REPORT TO DESIGN REVIEW BOARD

SUBJECT: 33/41 Ross Street Terrace – Request for a Lot Line Adjustment for property line adjustment, Exception, and Environmental and Design Review Permits to allow: (1) Construction of a 2,842 square-foot, single-family residence on vacant hillside Lot 59; (2) Construction of a 2,885 square foot residence on vacant hillside Lot 60; and (3) Construction of a two lane access driveway approximately 480 feet in length within the undeveloped Ross Street Terrace right-of-way; APN: 012-141-59 and 012-141-60; Single-family Residential (R7.5) District; Coby Freidman, applicant. File No(s): LLA19-008/ED19-090/ED19-091/EX20-006.

TS
 Ross Terrace
 San Rafael, CA

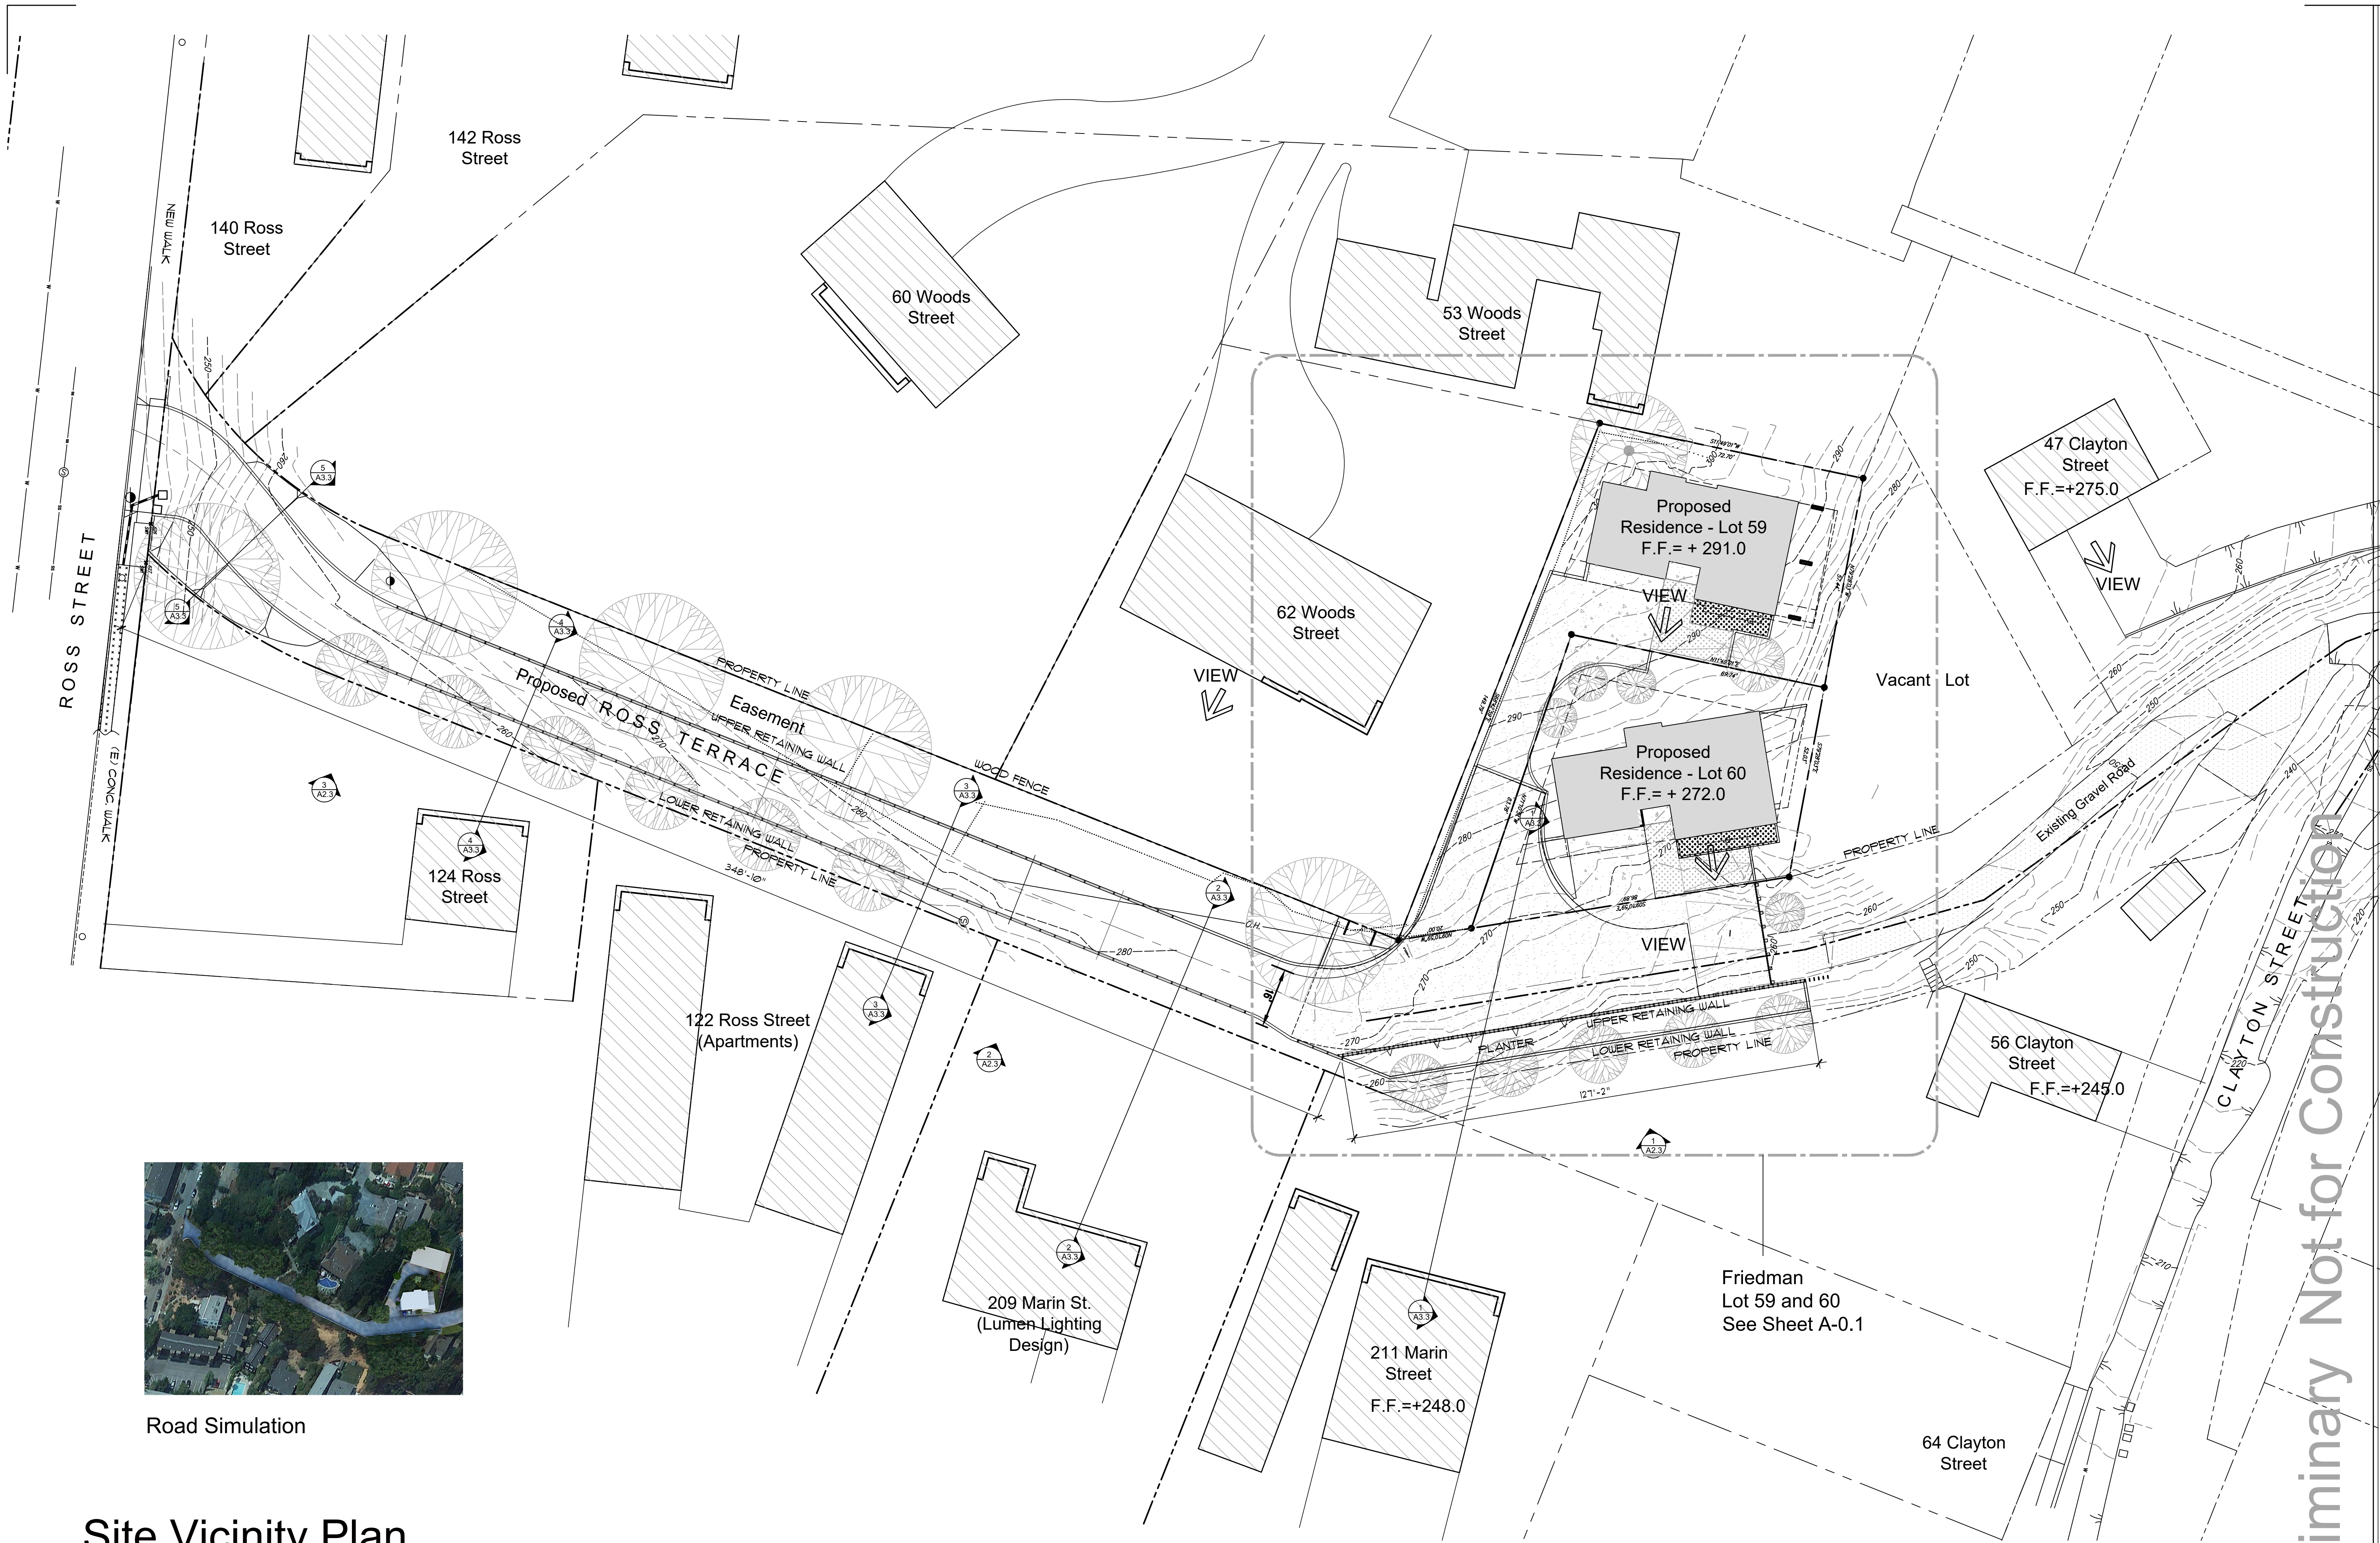
- *Lot 59 - The minimum natural state required for this lot is 3,610 square feet. The applicant's data (Sheet TS) proposes a total natural state of 1,957 square feet, which is less than the minimum required and therefore an exception to the natural state requirement is requested. In comparison, proposed lot is 78% in size (only 60% of the minimum lot size if the panhandle is*

- Lot 60 - The minimum natural state requirement for this lot is 3,283 square feet. The applicant's project data (Sheet TS) proposes a total natural state of 1,741 square feet, which is less than the minimum required and therefore an exception to the natural state requirement is requested. In comparison, proposed lot is 67% in size; 1,741 square feet is about 53% of the required minimum natural state.

Proposed
Road Sections
Ross Street
Terrace

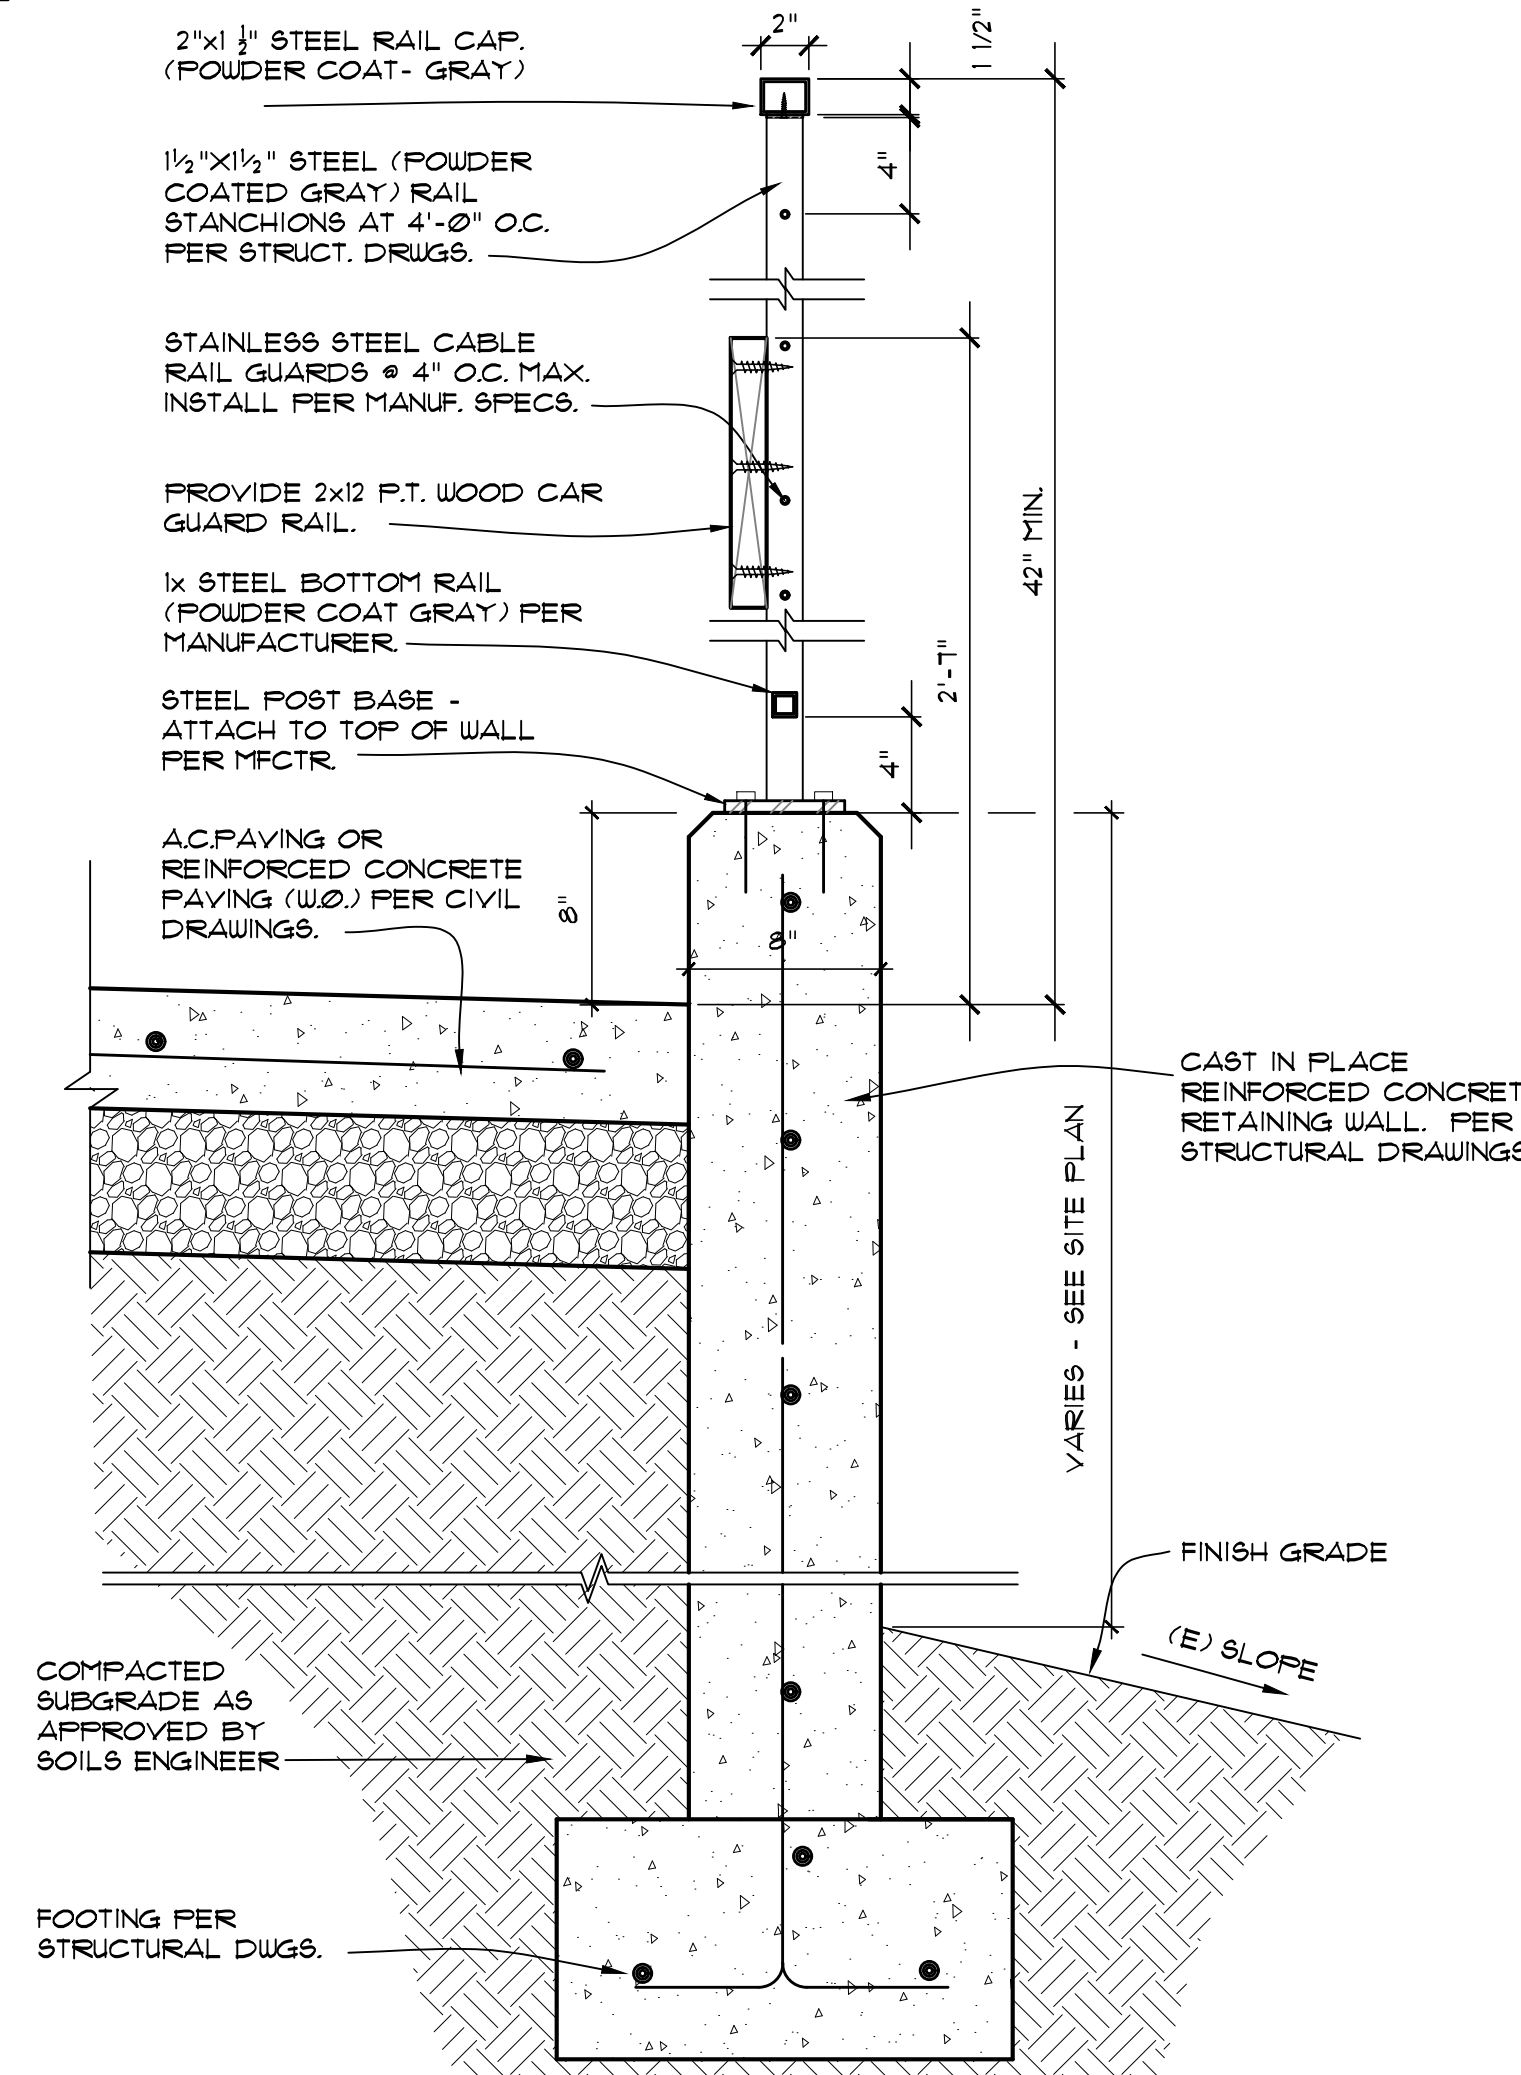
- 4) **Unclear plans.** The Roadway Section page (A 3.3) shows a small gradual hill at the bottom of the proposed retaining walls at our property. It doesn't show a 24' cliff between the road and our property (see Figure 1). We believe that the representation on the
